**PLANNING & ZONING COMMISSION  
Regular Meeting  
Wednesday, December 21, 2016  
6:30 p.m.**

**A. 23-18 Old Town Square PUD Amendments  
and Final Plat**

**C. 16-10 Vistancia Annexation, Rezoning, and  
Preliminary PUD.**

SUBJECT: Case 2003-18 Old Town Square PUD Amendment and Final Plat

**Figure 1** The original site plan from the 2004 PUD and Rezoning ordinance illustrates the existing approvals and building configuration.

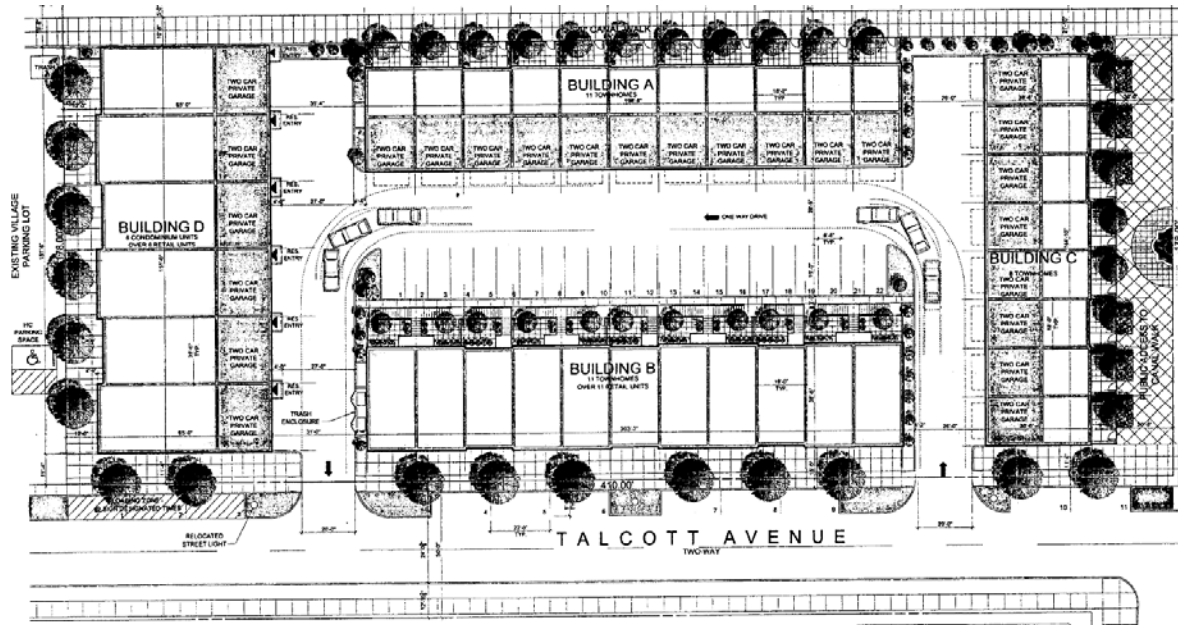
The subject property was originally granted a PUD and rezoning in 2004. The PUD allowed the applicant four buildings A-D (Figure 1). Building A, the north building constructed along the I&M Canal is comprised of 11 townhomes. Building D is the mixed use building along the west side of the subject property with six commercial units with six residential condominiums on the second floor. Building B, south building along Talcott Ave. which has

**Figure 1** The arrow indicates where the subdivision sign and landscaping should be moved to improve the sightlines of the proposed intersection. The x's indicate the landscaping that should be removed.

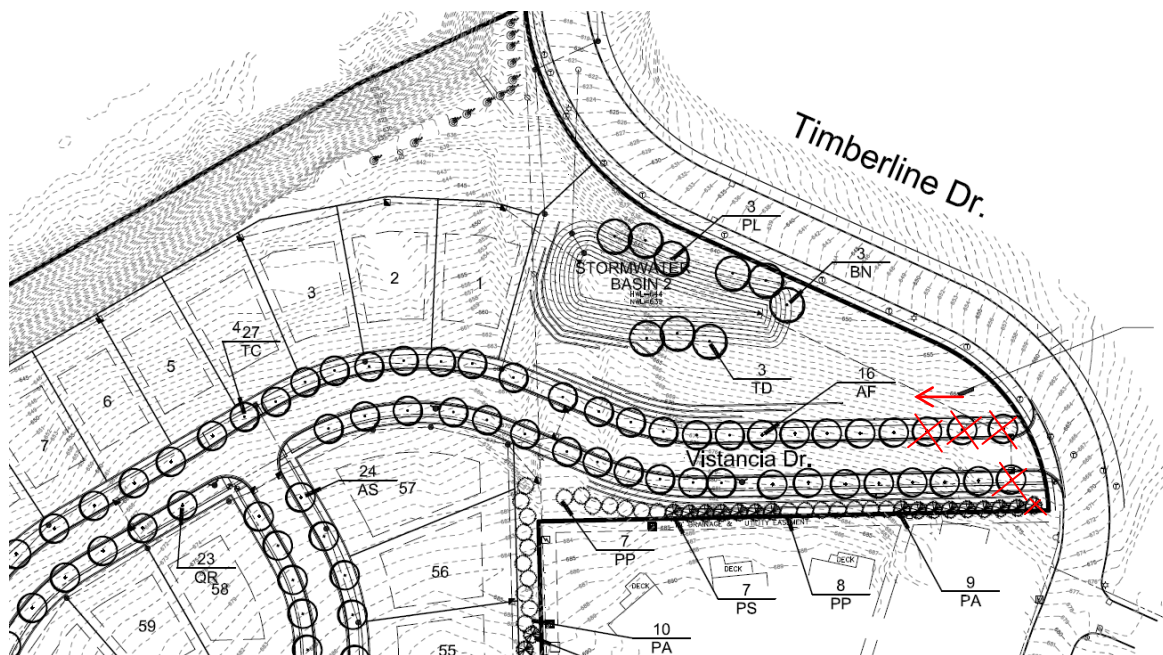
The proposed landscaping around the north side of the Timberline Dr. entrance is a concern of staff. Staff is recommending that three (3) of the parkway trees along the north side of Vistancia Dr. be removed and the landscaping for the subdivision sign be shifted west (Figure 1). One (1) parkway tree and one (1) evergreen tree are also being recommended for removal along the south side of the Timberline Dr. entrance as well. The removal/shifting of this landscaping will improve the safety of the intersection by allowing traffic utilizing Timberline Dr. and Vistancia Dr. to more easily see vehicles approaching the proposed intersection.
